**DSP-95073-06**

## Kaiser Permanente Largo Medical Center

STAFF REPORT

SUBJECT: Detailed Site Plan DSP-95073-06  
Kaiser Permanente Largo Medical Center

**Figure 1: Site Plan**

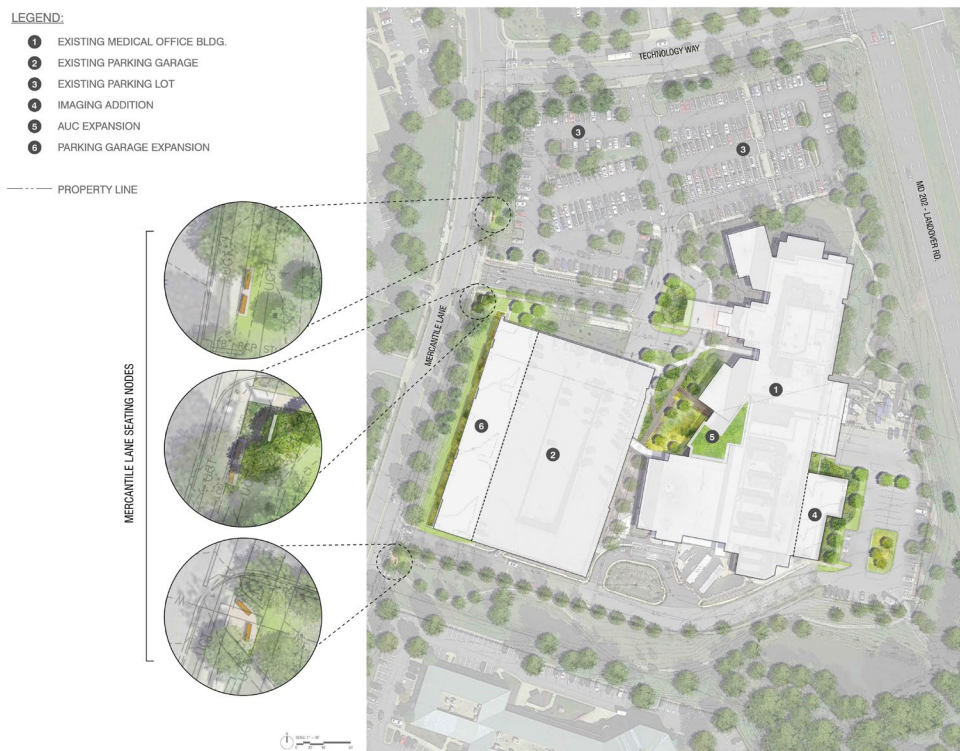
The site can be accessed from three existing points of ingress/egress: two along Mercantile Lane and the third along Technology Way. Phase 1 will include the proposed 4,850-square-foot expansion of the Advanced Urgent Care center, to modernize the existing facility with 15 new treatment rooms and supporting laboratory space. The on-site vehicular circulation will be revised by adding a 22-foot-wide two-way drive aisle and a covered drop-off area at the main entrance. Phase 2 includes the 6,200-square-foot expansion of the existing imaging facility and incorporation of new environmental site design features such as green roofs, native plantings, and a SWM facility. The DSP also proposes to construct an 80,000-square-foot addition to the existing parking garage in phase one, which will replace existing surface parking adjacent to Mercantile Lane.

Loading is required for the medical office building and is provided on the east side of the building adjacent to the proposed imaging addition. The trash facilities are interior to the building and not proposed to change with this application. The loading spaces are set back from MD 202 and are adequately screened by landscaping and a brick wall. Labels showing the dimension and location of these spaces have not been included on the site plan and should be provided. Therefore, a condition has been included to clearly dimension these spaces and label them on the DSP for clarification.

- a. Modify the northbound approach lane use configuration along Mercantile Lane to include a single left-through and single right-through lane configuration. The exact details shall be accepted by the Transportation Planning Section.

- b. Add additional stop controls at the eastbound approach and outbound lane of the pickup/drop-off area internal to the site at Mercantile Lane. The exact details shall be accepted by the Transportation Planning Section.

- c. Add signage indicating temporary parking along the pickup/drop-off area. The exact location and sign profiles shall be accepted by the Transportation Planning Section.

**Figure 2: Parking Garage Elevations**

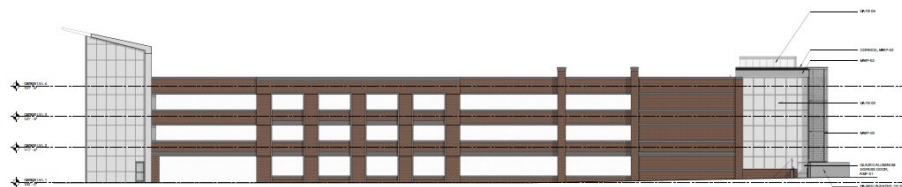
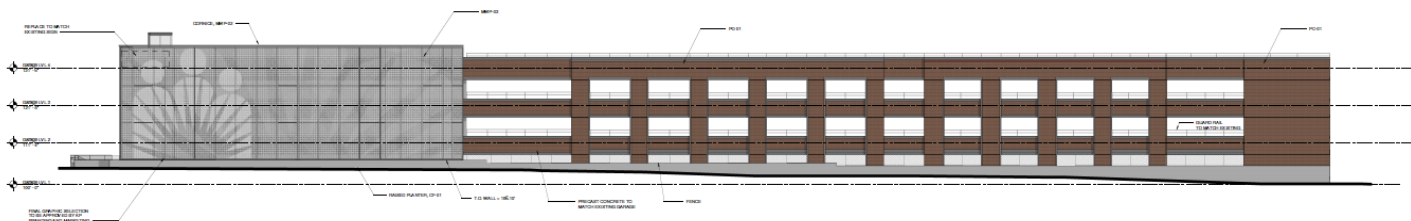
The applicant is requesting a modification to this Development District Standard to amend the build-to line placement to 45 feet. This DSP proposes a garage addition to be constructed within 45 feet of the Pedestrian Zone, along Mercantile Lane. The addition brings the garage closer to the street, and promotes a more continuous street façade, as recommended by the Largo Town Center Sector Plan and SMA. In addition to bringing the building closer to the pedestrian zone, the applicant also proposes to activate the street through the addition of 3 seating areas, which further enhances and connects to the existing pedestrian loop. Within these seating areas, the applicant proposes benches, bollard lighting, and enhanced landscaping. These improvements advance the brand of New Urbanism envisioned by the Largo Town Center Sector Plan and SMA. For these reasons, staff recommends approval of this modification.

The applicant states that the expansion of the parking garage is within view of the public realm and is a four-story structure. It is designed to align with the existing garage and will maintain existing clear heights, which were approved pursuant to the I-3 zoning on-site. The proposed improvements will allow for a contiguous connection and provide adequate vehicular circulation throughout the parking structure. For these reasons, staff recommends approval of this modification.

The applicant indicates that the percentage of openings for the proposed structured garage will be consistent with the existing parking garage that was built according to the I-3 Zone standards. The fenestration size proposed in this DSP is consistent with the existing parking garage, and by maintaining this relationship it will retain the structural integrity. For these reasons, staff recommends approval of this modification.

- A. APPROVAL of the following alternative Development District Overlay Zone standards:
  - 1. **Urban Design Criteria Block Length** (page 133)—To allow a maximum block length of 675 feet.
  - 2. **Urban Design Criteria Build to Line** (page 135)—To allow the proposed garage addition to be constructed within 45 feet of the Pedestrian Zone.
  - 3. **Urban Design Criteria Frontage** (page 138)—To allow a minimum building frontage of 45 percent.
  - 4. **Urban Design Criteria Building Heights** (page 141)—To allow the proposed garage expansion to maintain the existing clear height.
  - 5. **Architectural Design Criteria Fenestration** (page 159)—To allow the fenestration of the proposed garage expansion to be consistent with the fenestration of the existing parking garage.

**Figure 5: Proposed Signage**

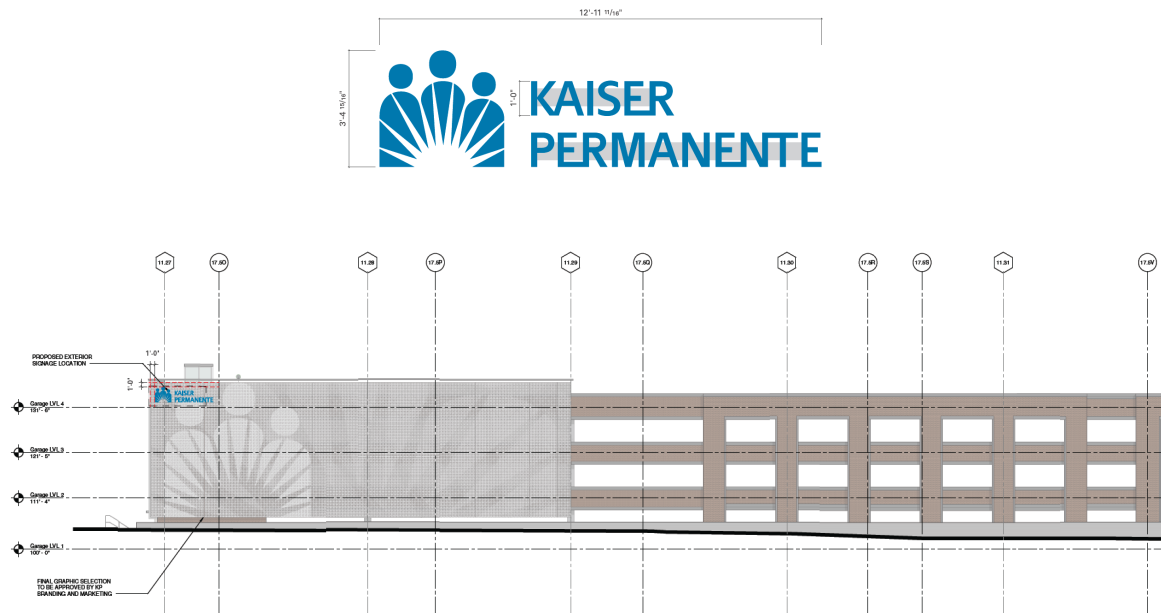
The applicant indicates the total allowed square footage for signs along Mercantile Lane is 654 square feet. The perforated graphic panel design includes portions of the Kaiser Permanente logo and is considered signage. The graphic design is a total of 928 square feet, which exceeds the allowed square footage by 274 square feet. The image is intended to be a mural, to screen the structured parking facility and add visual interest to the streetscape of Mercantile Lane. Its approval will enhance the proposed development and promote the goals and objectives of the development district by screening parking from the public realm, defining the vertical definition of the street, and activating the streetscape. For these reasons, staff recommends approval of this modification

6. **Architectural Design Criteria Fenestration** (page 170)—To allow the signage on Mercantile Lane to exceed the allowed sign square footage by 274 square feet for the installation of a graphic panel design on the western façade of the parking garage facing Mercantile Lane.
